STAFF RECOMMENDATION
1510 Paris Avenue
October 16, 2019

Application: New construction- Addition and Outbuilding
District: Belmont-Hillsboro Neighborhood Conservation Zoning Overlay
Council District: 18
Base Zoning: R8
Map and Parcel Number: 117040195.00
Applicant: Betsy Bergin
Project Lead: Jenny Warren, jenny.warren@nashville.gov

<p>Description of Project: Application for the construction of a rear addition and an outbuilding.</p> <p>Recommendation Summary: Staff recommends approval with the condition that staff shall review and approve the final foundation material, siding exposure, roofing color, windows, doors and garage doors, finding the proposed new construction meets the design guidelines for the Belmont-Hillsboro Neighborhood Conservation Zoning Overlay.</p>	<p>Attachments A: Photographs B: Site Plan C: Elevations</p>
--	--

Figure 4: Rear elevation, proposed addition in red

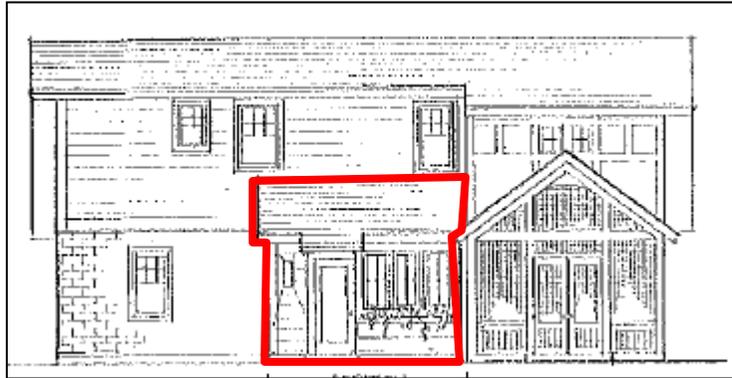
Height & Scale: The proposed addition is both shorter and narrower than the historic house. It is very modest in size, measuring approximately fourteen feet (14') by thirteen feet (13').

The addition is one story tall with a height of about thirteen feet (13'), while the back of the house is two stories tall with a height of about twenty-three feet (23').

Design: The existing house is painted brick and the addition will be lap siding. The addition's change in materials, inset, separate roof form, and lower height help to distinguish it from the historic house and read as an addition to the house. At the same time, its scale, materials, roof form, and fenestration pattern are all compatible with the historic character of the existing house. The project meets section II.B.2.a and f.

With staff review and approval of the foundation material, the siding exposure, the roof color and the final doors and windows, the project meets section II.B.1.d

Figure 5: Proposed location of addition

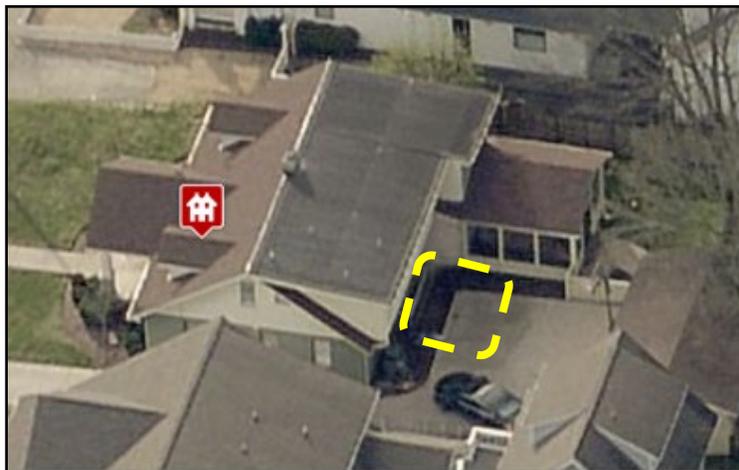
The location of the addition will be on the rear of the house, within an existing L-shape of the footprint. Thus the new construction will add neither depth nor width to the existing footprint. This location is in accordance with the design guidelines. The addition is designed so that if the addition were to be removed in the future, the historic character of the house would still be intact. The project meets section II.B.2.a and e.

Figure 6: Proposed outbuilding – side

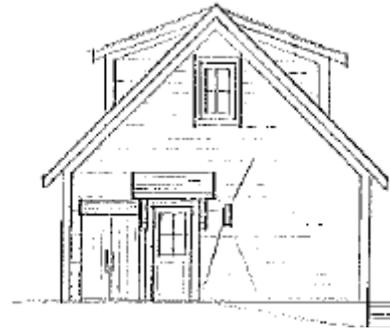
The proposed ridge height will be approximately twenty feet (20') tall, which is less than the twenty-three foot (23') tall house and less than the twenty-five foot (25') maximum. The eave heights will vary a bit, due to grade, but will be an average of about nine feet (9') tall which meets the guidelines.

Staff finds that the proposal will meet Section II.B.1.i of the design guidelines.

Figure 7: Proposed site plan – arrow indicates 16’ (sixteen feet) of separation from the rear wall of the house to outbuilding

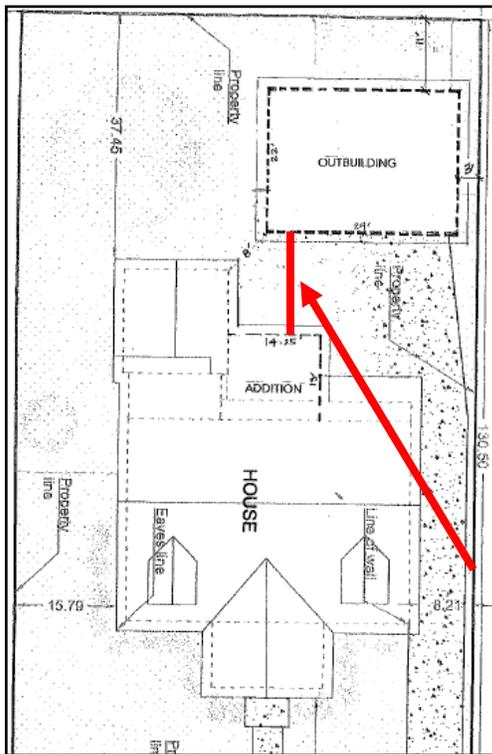
The guidelines state that ‘*there should be a minimum separation of 20’ between the principal structure and the DADU or outbuilding*’. The applicant is proposing sixteen feet (16’) of separation between the back of the new addition and the outbuilding. Staff finds that this could be appropriate, because the lot is shallow, at one-hundred-thirty feet (130’) deep. In the past, the Commission has allowed applicants to reduce the distance between the house and outbuilding if the lot is less than one-hundred-fifty feet (150’) deep.

Staff finds that the project meets section II.B.1.i of the design guidelines.
